# UNITED STATES PATENT AND TRADEMARK OFFICE

APPLICATION NO.	FILING DATE	FIRST NAMED INVENTOR	ATTORNEY DOCKET NO.	CONFIRMATION NO.
10/810,952	03/26/2004	Michael David Pleskach	7162-0119	9829
39207	7590	12/29/2005	EXAMINER	
SACCO & ASSOCIATES, PA			MAI, ANH T	
P.O. BOX 30999			ART UNIT	
PALM BEACH GARDENS, FL 33420-0999			PAPER NUMBER	
			2832

**Office Action Summary**

**DETAILED ACTION**

**FIG. 5**

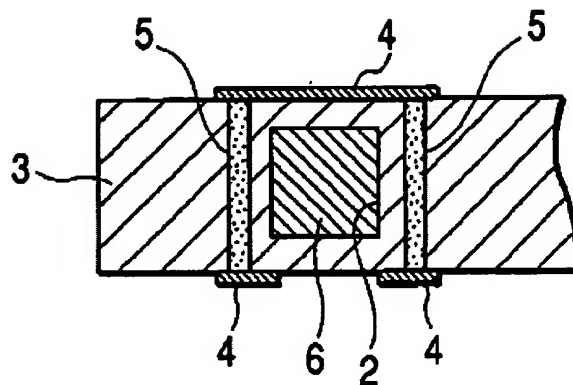
Aoyagi discloses a ceramic substrate 3; a ceramic core embedded within said ceramic substrate; at least one conductive coil 4,5 comprising a plurality of turns about ceramic core integrally formed with ceramic substrate in co-firing process [low temperature co-fired ceramic LTCC substrate is used, see paragraph 0014]. Figure 5 shows the ceramic core part embedded in ceramic substrate [the area surround by conductive coil 4,5 and perimeter 2, since applicant does not exclude any other material of the ceramic core, figure 5 reads on limitation of claim 1]. Also, the plurality of turns is contained within ceramic substrate at all points [figure 4].

Aoyagi discloses the invention as claimed except for the ceramic core having toroidal shape. Harding however, discloses the toroidal shape of the transformer core as shown in figures 2-4.

It would have been obvious, therefore, at the time the invention was made to a person having skill in the art to construct the transformer core as disclosed by Aoyagi, with toroidal shape as position, as disclosed by Harding for the purpose of obtaining a circular flux path [col 3, lines 63-64 and col 4, lines 15-19].

Fig. 15

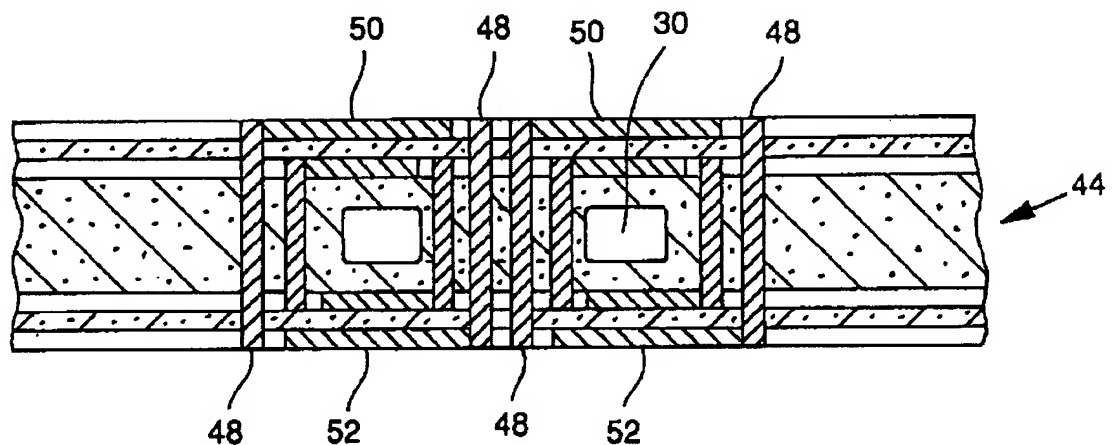
With respect to claim 23, Krone discloses second conductive traces 50 and vias 48 as shown in figure 15.
